PREVOST

**WARRANTY
BULLETIN**

Wb00-07A

DATE : NOVEMBER 2000	SECTION : 06 - Electrical
EXPIRATION: NOVEMBER 2001	
SUBJECT : KEYLESS ENTRY KEYPAD REPLACEMENT

FIGURE 1: INSTALLATION OF THE DECAL AND KEYPAD ON H3-45 VIP

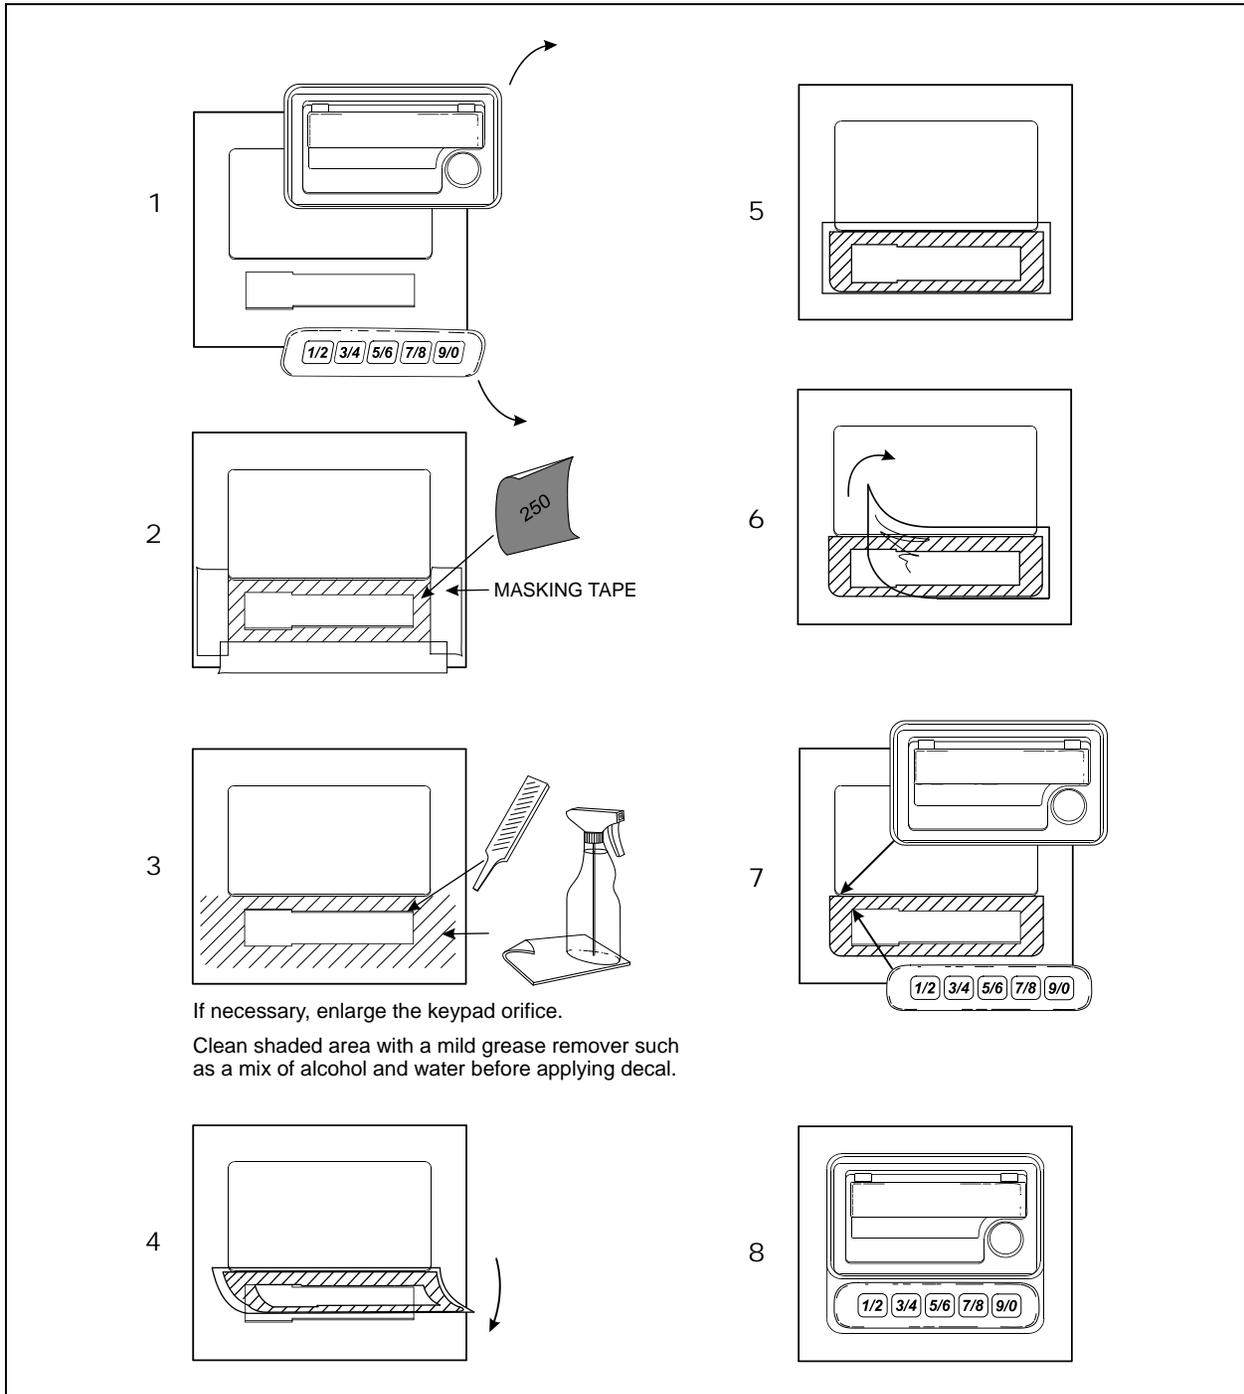
Refer to figure 1.

- ❖ Remove the door handle;
- ❖ Mask the paint surrounding the keypad hole and sand down the paint edges so they don't show behind the decal (use sandpaper grit of about 250);
- ❖ Clean the door surface with a degreasing agent such as a mixture of water and alcohol;
- ❖ Apply decal #065422 in position (refer to figure 1 and to the instructions below for proper installation):
 - Remove the white bottom layer;
 - Apply the upper portion (straight edge, no rounded corners) along the edge of the hole in the plate where the handle assembly sits;
 - Apply the decal by smoothing downward to avoid trapping air bubbles;
 - Remove the translucent top layer;
